# Amesbury School Building Committee November 19, 2020

# Amesbury Elementary School

# Project Updates

# Waiver Request 2 | Zoning Bylaw Section VIII.G.17

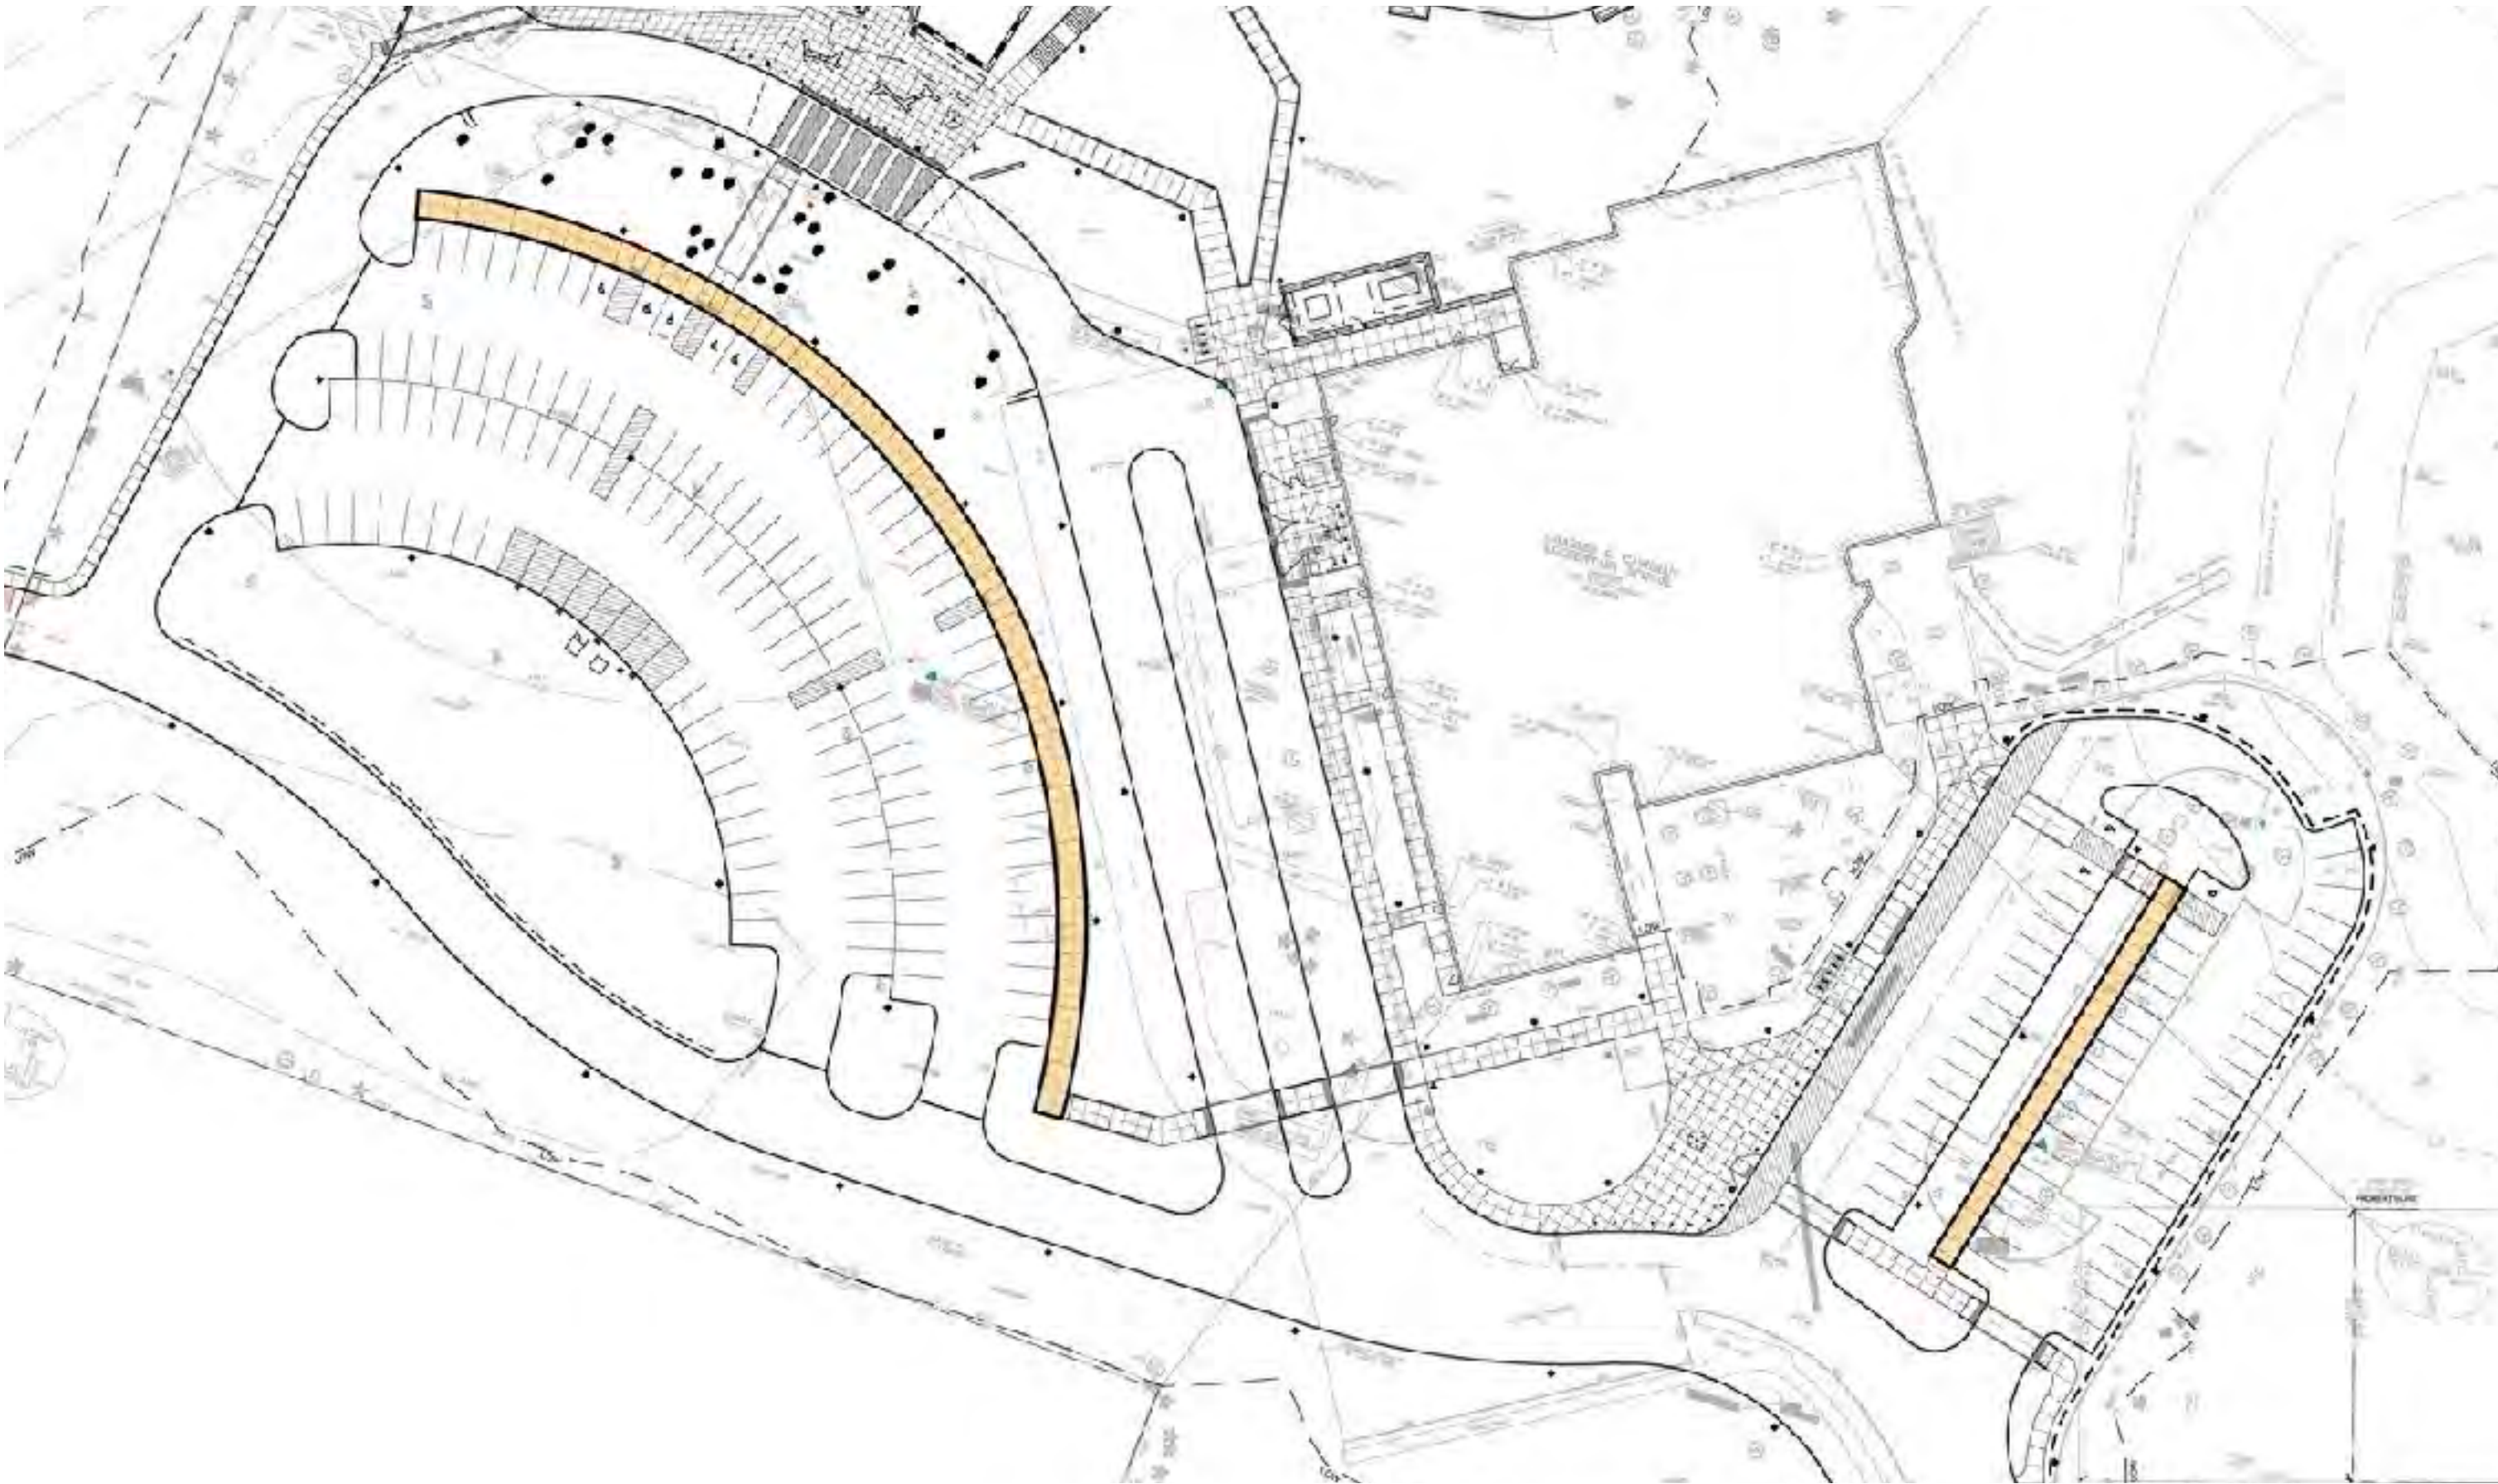
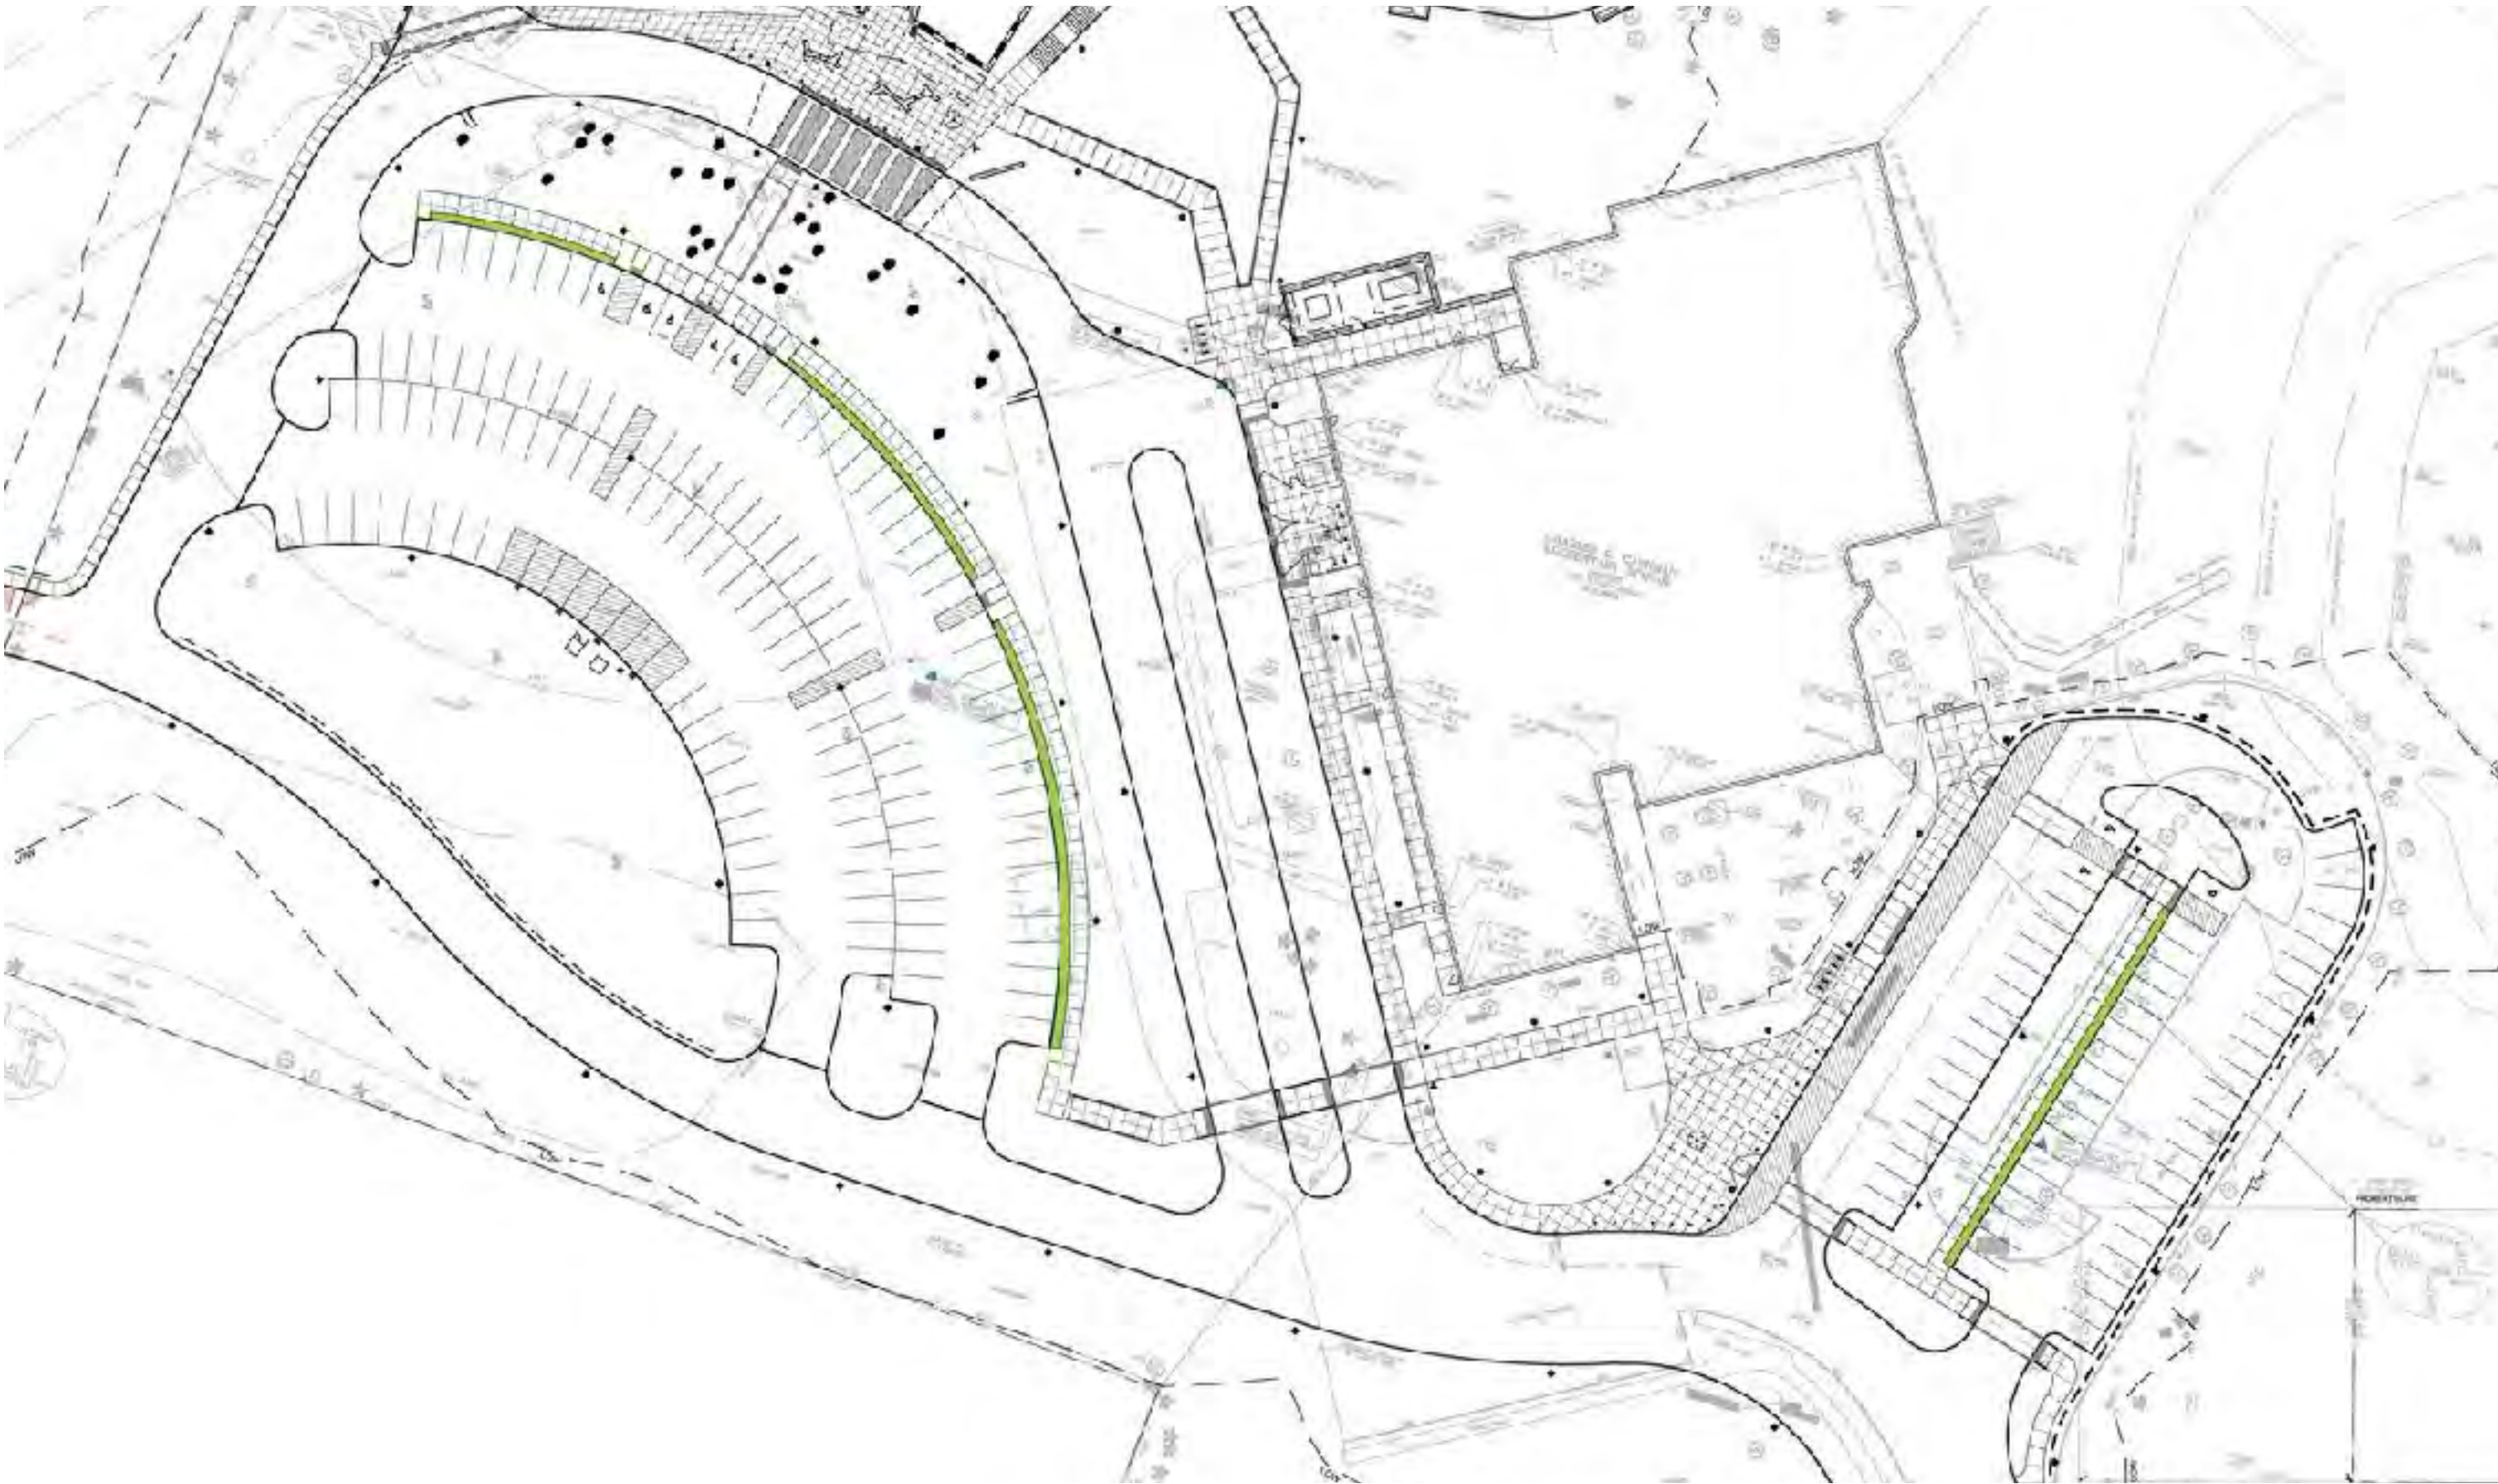
Required	Proposed
Vehicle Overhang	3 feet	-

AES: The sidewalks abuts the curb. The curb is (6) inches wide and the sidewalk is (10) feet wide for a total of (10) feet (6) inches. With the (3) foot wide overhang for the vehicle there is a clear path of (7) feet (6) inches for pedestrians.

CES: The sidewalks abuts the curb. The curb is (6) inches wide and the sidewalk is (8) feet wide for a total of (8) feet (6) inches. With the (3) foot wide overhang for the vehicle there is a clear path of (5) feet (6) inches for pedestrians.

The DPW has stated that they would prefer that the paving extend to the curb and the sidewalk be widened to accommodate pedestrian movement for ease of maintenance and snow plowing.

# Waiver Request 2 | Zoning Bylaw Section VIII.G.17

Required	Proposed
Vehicle Overhang	3 feet	3 feet

# Waiver Request 3 | Pipe Material & Cover

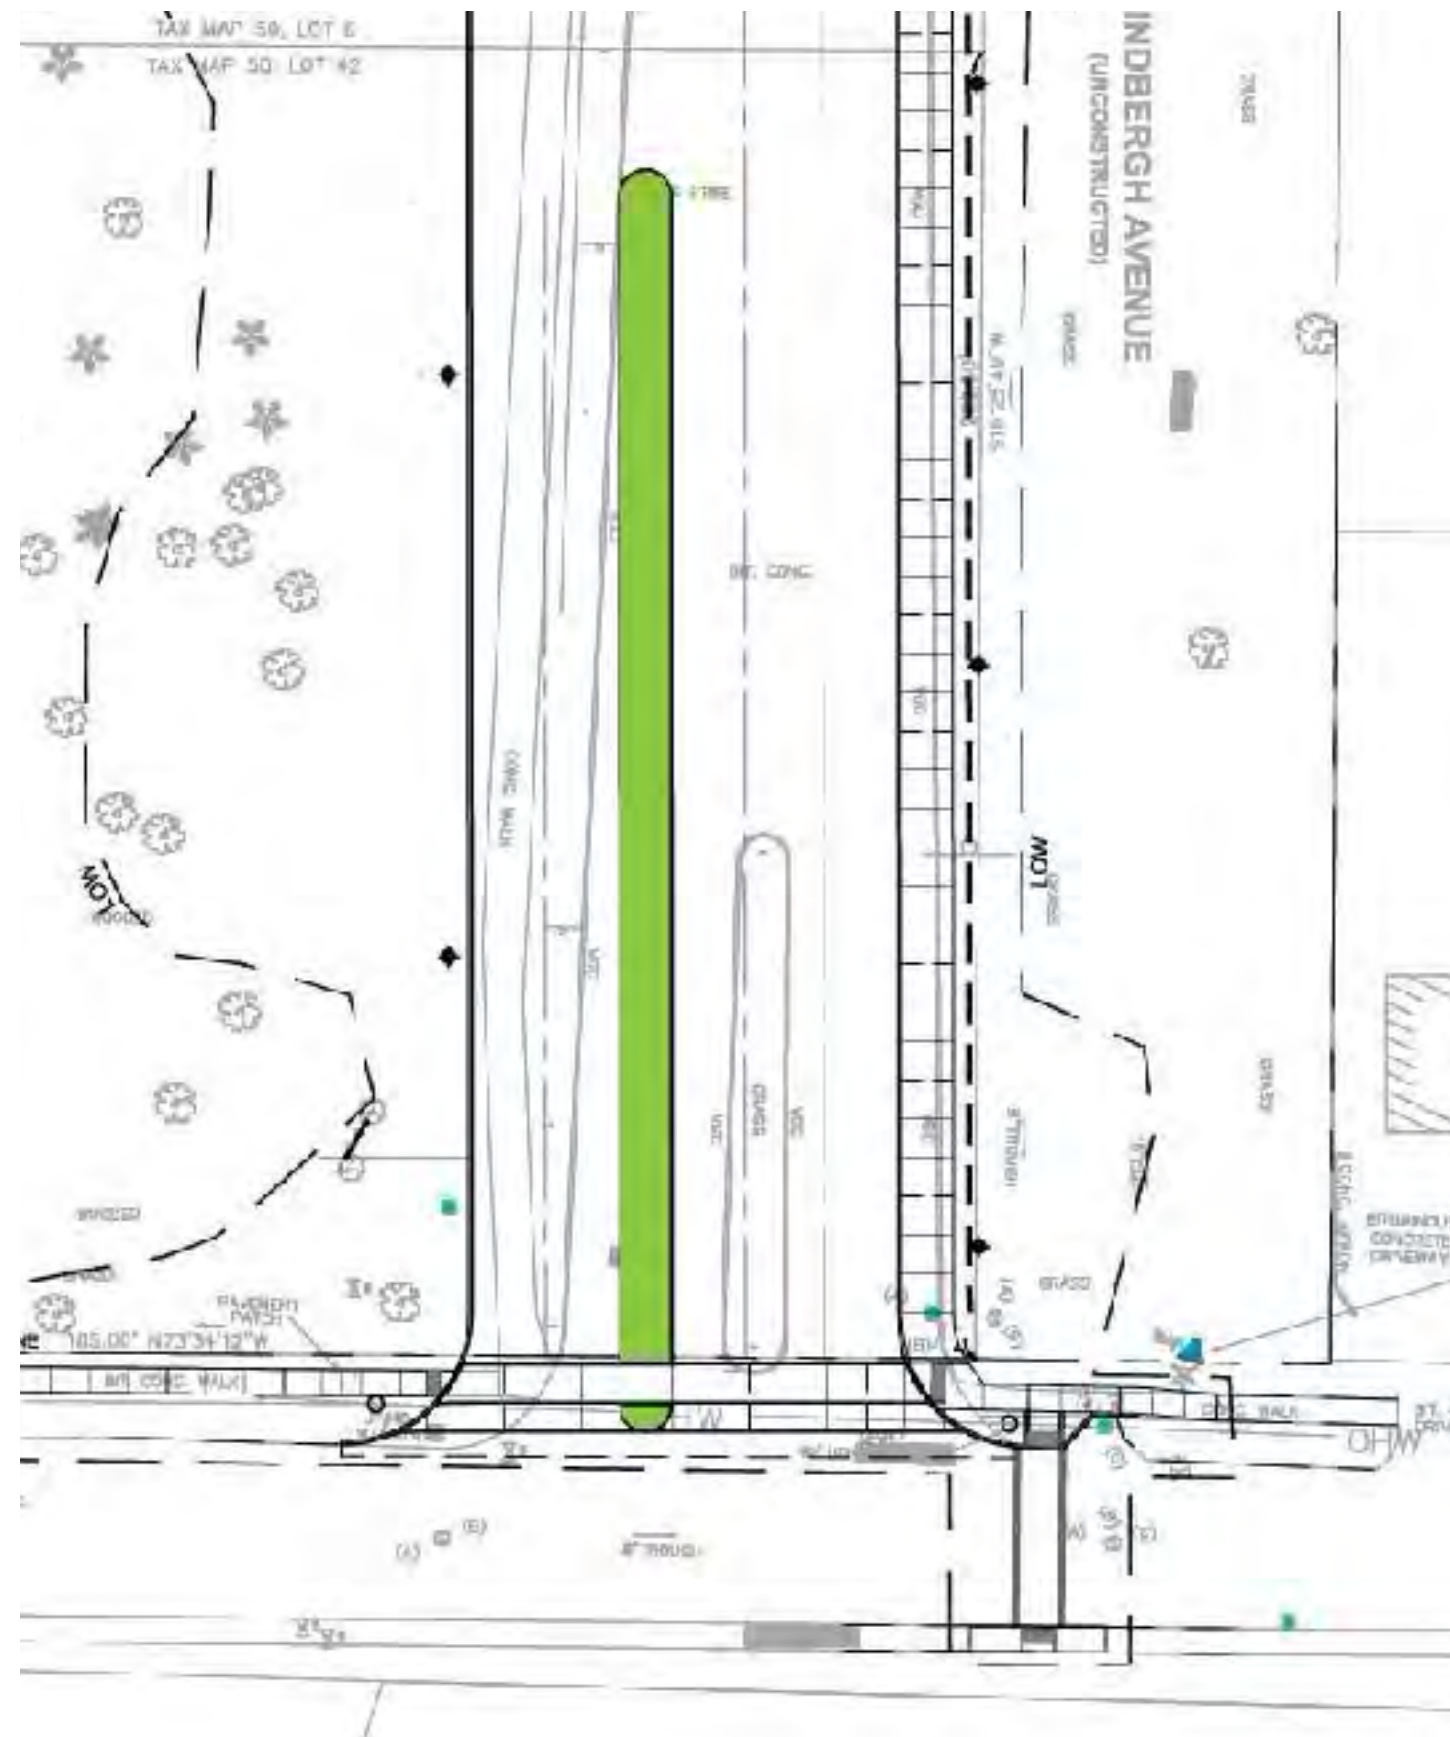
The project is proposing to use HDPE pipe for all drainage pipe. There are only a few isolated incidents where there will be less than 3 feet of cover over the drainpipes. Please note that there is a minimum of 2.5 feet of cover over the pipes with less than the 3 feet required.

Required	Proposed
Pipe Material	Reinforced Concrete	HDPE
Minimum Cover	3 feet	2.5 feet

After consulting with the City of Amesbury DPW, they are in favor of the HDPE pipe material. DPW regularly uses this pipe throughout the City and acknowledges the benefits of designing a cost-conscious system with modern pipe materials.
